Transport Review (Flow Transportation Specialists)

IN THE MATTER of the proposed Private Plan Change 83 (Cove
Road, Mangawhai Heads) ("**PC83**") lodged by The
Rise Limited ("**Applicant**")

**STATEMENT OF EXPERT EVIDENCE OF LUKAS GERHARD VAN DER
WESTHUIZEN ON BEHALF OF NORTHLAND TRANSPORTATION ALLIANCE**

31 JANUARY 2024

Figure 2: PC83 indicative road and walking and cycling network included in the new Transport Assessment

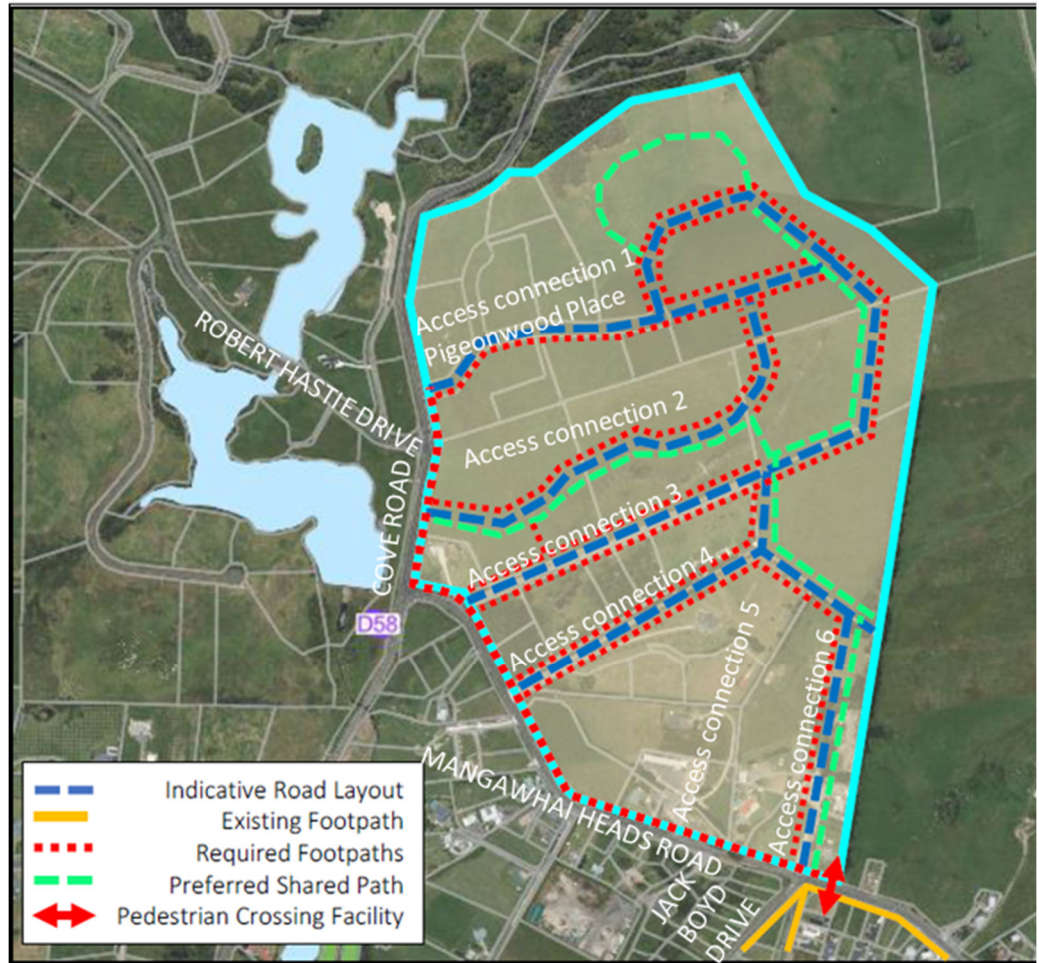
- 6.52 In Mr Kelly's New Transport Assessment, a shared path is proposed internal to the PC83 area (refer to Figure 2), however only a footpath is proposed on the northern side of Mangawhai Heads Road and the eastern side of Cove

- 6.53 For a resilient and connected network, I recommend that a shared path is provided on Cove Road / Mangawhai Heads Road. It is especially important to provide the appropriate provisions for pedestrians and cyclists, in case the internal (internal to PC83 area) shared path network is deferred.

Figure 6: Proposed changes to indicative transport network

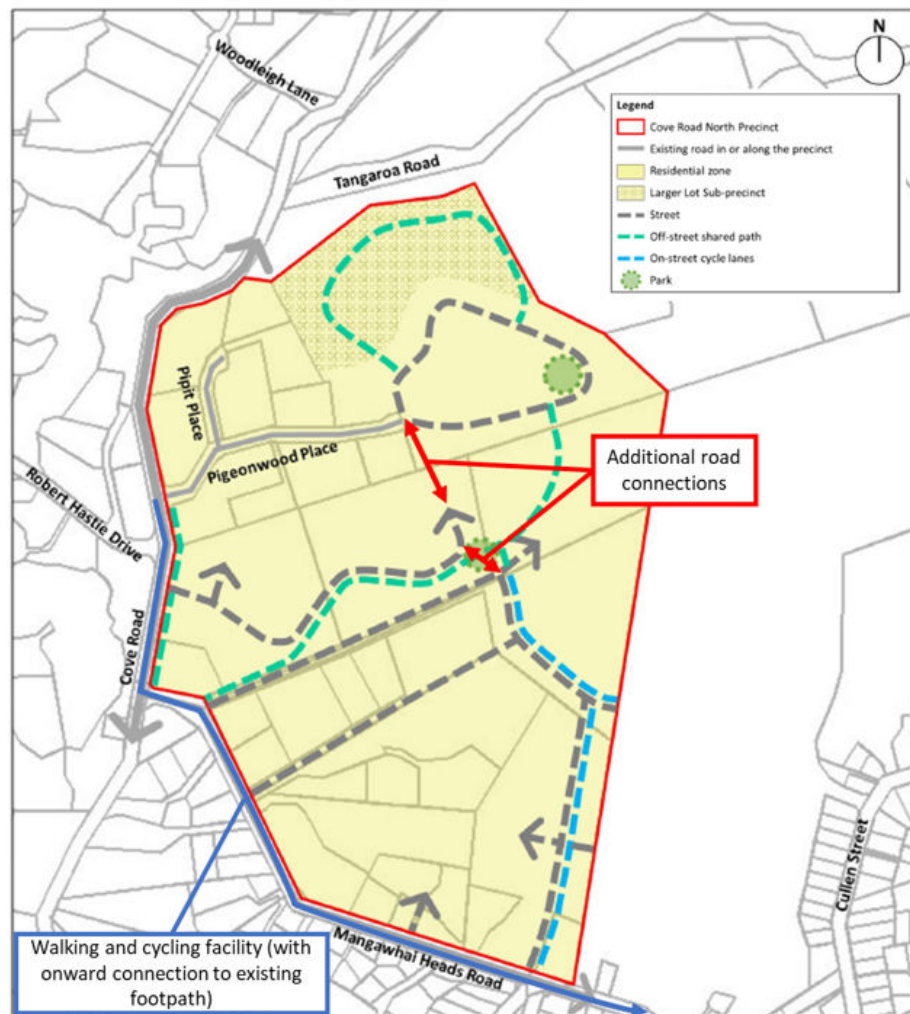
- 6.56 The Applicant's previous transport plan displays three separate street networks without connections between them. Mr Jongeneel suggested that better connectivity within the PC83 area can be achieved by adding street connections, as shown by the red arrows in Figure 6 below.
- 6.57 Mr Jongeneel's recommendation to the Applicant was to update the transport plan to include these street connections within the Precinct. Once updated, the Council can make these improvements mandatory in the Precinct rules, specifying when they should be implemented. I agree with Mr Jongeneel's recommendation.

Figure 7: Conceptual Road Network

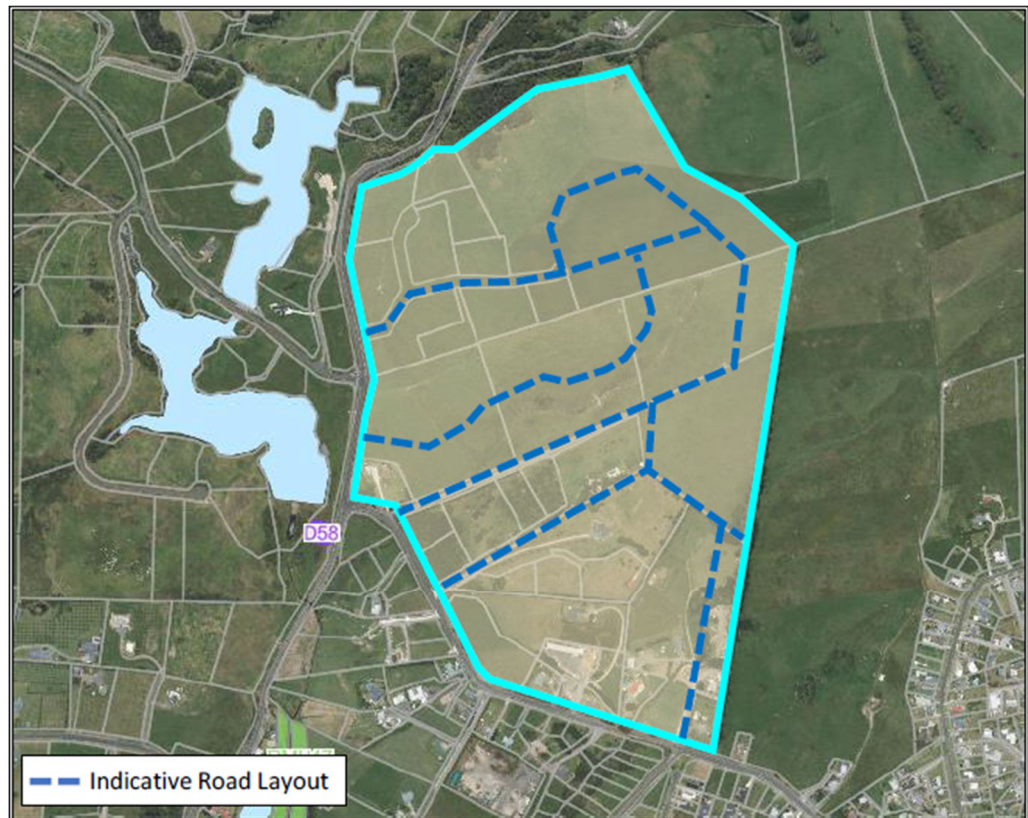
- 6.58 At the 27 April 2013 meeting, the Applicant's previous transport engineer agreed to provide an amended indicative transport plan through the Hearing process.
- 6.59 The Applicant has now included an indicative roading network as part of the New Transport Assessment which addresses Mr Jongeneel's recommendations. This is shown in Figure 7 below.

Figure 8: Land not owned by the applicant shown in orange superimposed on proposed roading network

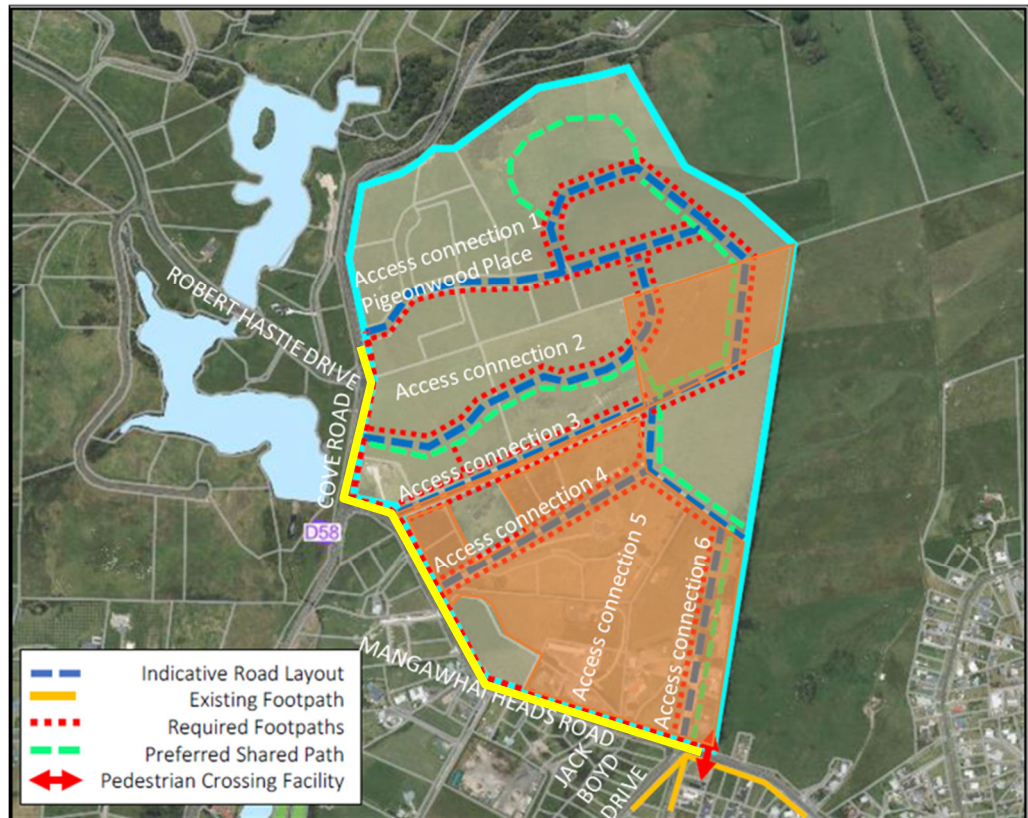
- 7.17 Some submitters have raised concerns that the proposed roading and cycling network within the PC83 area may not be feasible, and/or that on-site roads should be finalised through PC83 prior to subdivision as some roads/cycleways traverse through existing properties not owned by the Applicant.
- 7.18 In particular, submitters have outlined that owners of numbers 76, 82, 126, 128 (two additional landowners), 130, 130A, 130B, 136 and 142 Mangawhai Heads Road, are collectively major land owners in the area. I have outlined these properties in orange in Figure 8.

7.20 I note that the road network plan is indicative and illustrates the roading and active mode connections holistically, as would be the intention if all the PC83 land is developed.

Figure 1: Proposed changes to indicative transport network

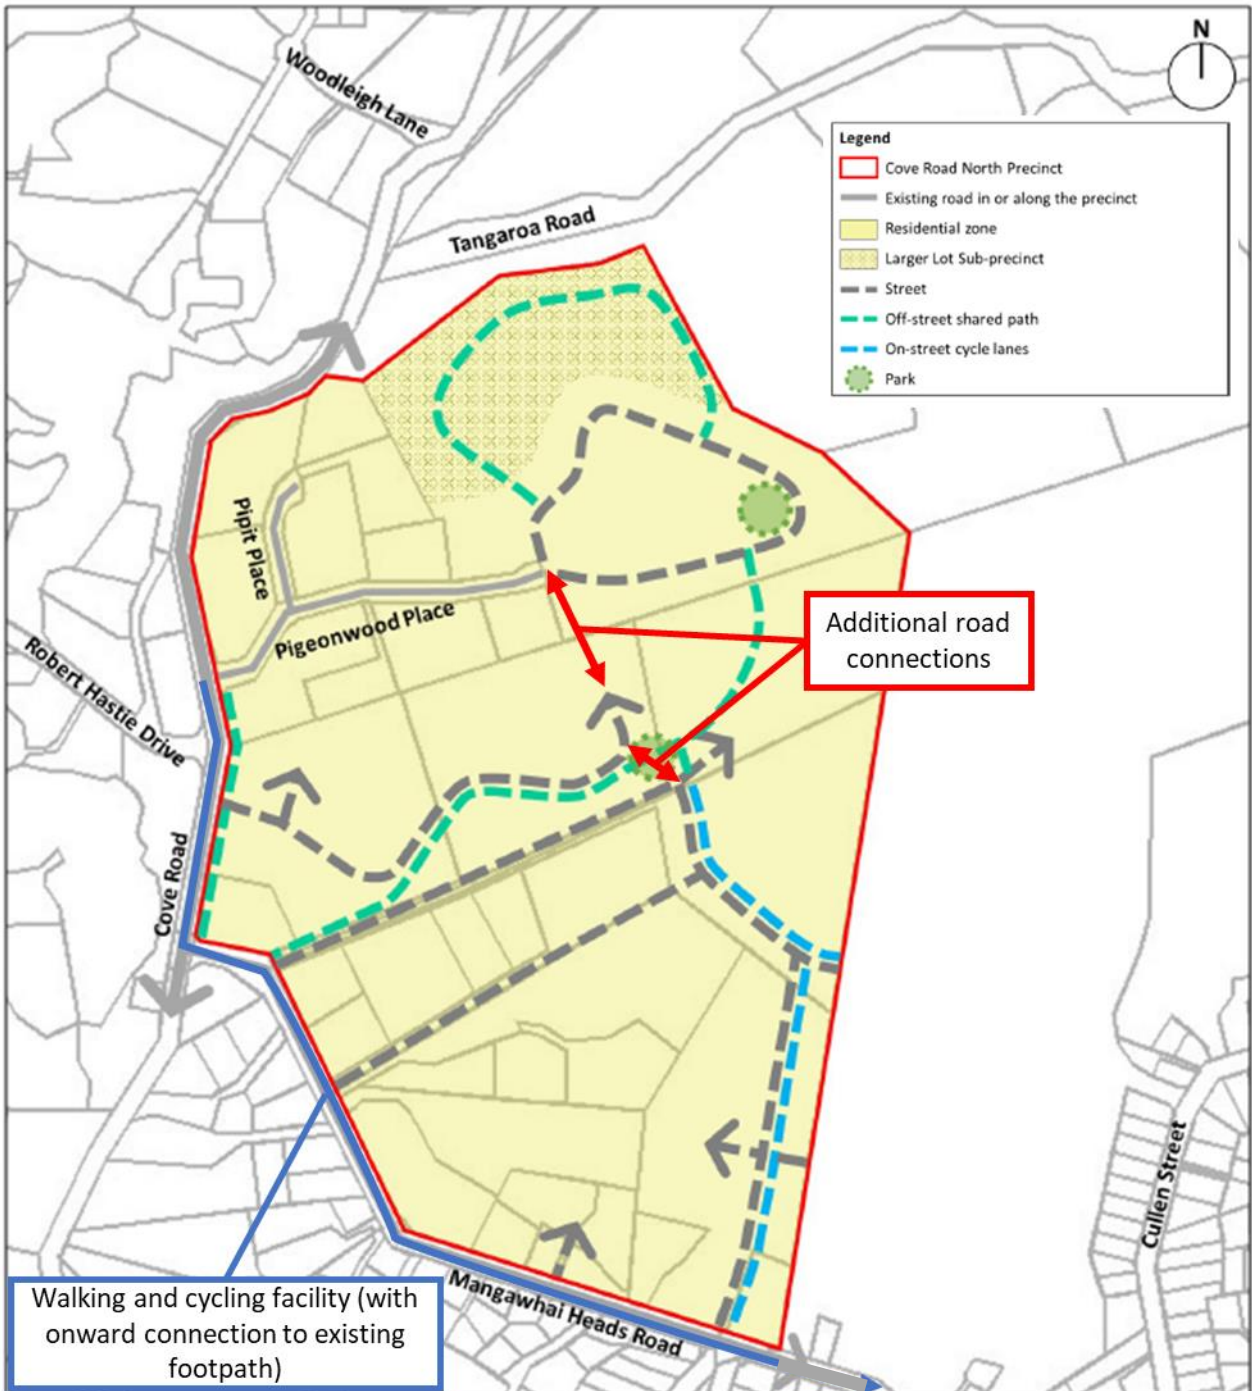
<p>9. The Plan outlines the indicative street and cycling connection on Mangawhai Heads Road but does not address the effects on the existing footpath on Mangawhai Heads Road and have shown an indicative off road shared path connecting to an existing footpath which would not be ideal. Request applicant to address this.</p>	<p>Again, it is only necessary that space be available for future installations or upgrades of such facilities. A future footpath along Mangawhai Heads Road is likely to be 1.8 metres wide and there is ample space within the road reserve for this even if the necessary space cannot be made available along site frontages (and it is likely this will be feasible). There is absolutely no reason why shared paths cannot be connected to footpaths. In fact, such is common, an example being the Hatea Loop path in Whangarei.</p>	<p>See above at 3.</p> <p>For reasons outlined above, we consider it is necessary to define an indicative walking and cycling network for the precinct at this stage.</p> <p>We suggest Council include a District Plan rule within the precinct plan requiring pedestrian upgrades and identifying triggers for when these must be delivered, including:</p> <ul style="list-style-type: none"> The urbanisation of the precinct's frontage to Mangawhai Heads Road and Cove Road (South of Pigeonwood – dependent on other proposed pedestrian connections) with sealed footpaths Safe, sealed connection to existing footpath on the southern side of Mangawhai Heads Road 	<p>No response provided by applicant.</p> <p>In response, we recommended that this indicative transport plan be amended to include footpaths/shared paths, as per items 1-3 above.</p>	<p>Addressed through items 1-3 above.</p>

Figure 2: Proposed changes to indicative transport network – January 2024

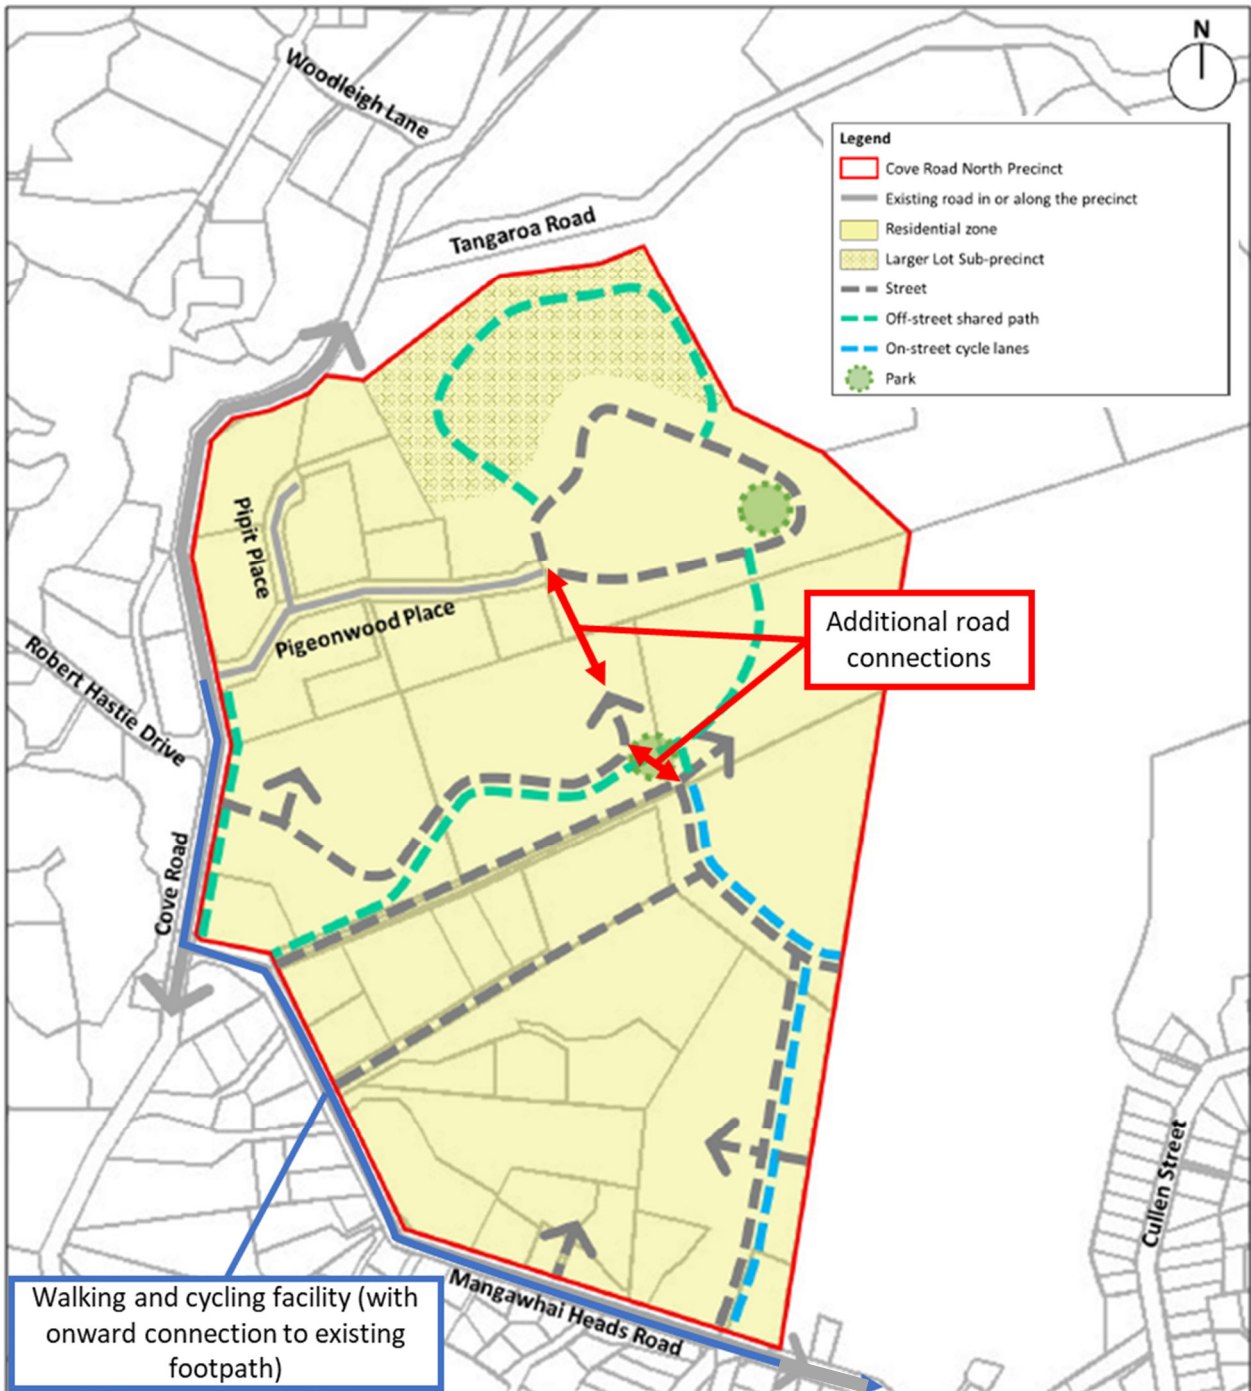
<p>18. 13.14.2 – Reads</p> <p>“the Cove Road North Precinct Road, Cycleway and Pedestrian Connection</p> <p>2. Council will have regard to the following additional matters when considering an application for resource consent under this rule within the Cove Road North Precinct:</p> <p>i. The extent to which any road, cycling and pedestrian connections are established in accordance with the Cove Road North Precinct Map 1 and Cove Road North Precinct Concept Plan 1”</p> <p>Request applicant to remove the wording “in accordance with Cove Road North Precinct Map 1 and Cove Road North Precinct Concept Plan 1” as the active modes connection has not been addressed completely.</p>	No response provided	Agree with NTA’s request. To be updated within the precinct rules.	<p>Precinct provision to be drafted.</p> <p>No response provided by applicant.</p>	<p>Matter potentially resolved subject to further information to be supplied at the Hearing.</p> <p>Subject to the applicant providing an amended indicative transport plan through the Hearing process, as per items 1-3 above.</p>	<p>Matter partially resolved.</p> <p>A shared path should be provided along the PC83 frontage on Cove and Mangawhai Heads Road.</p>
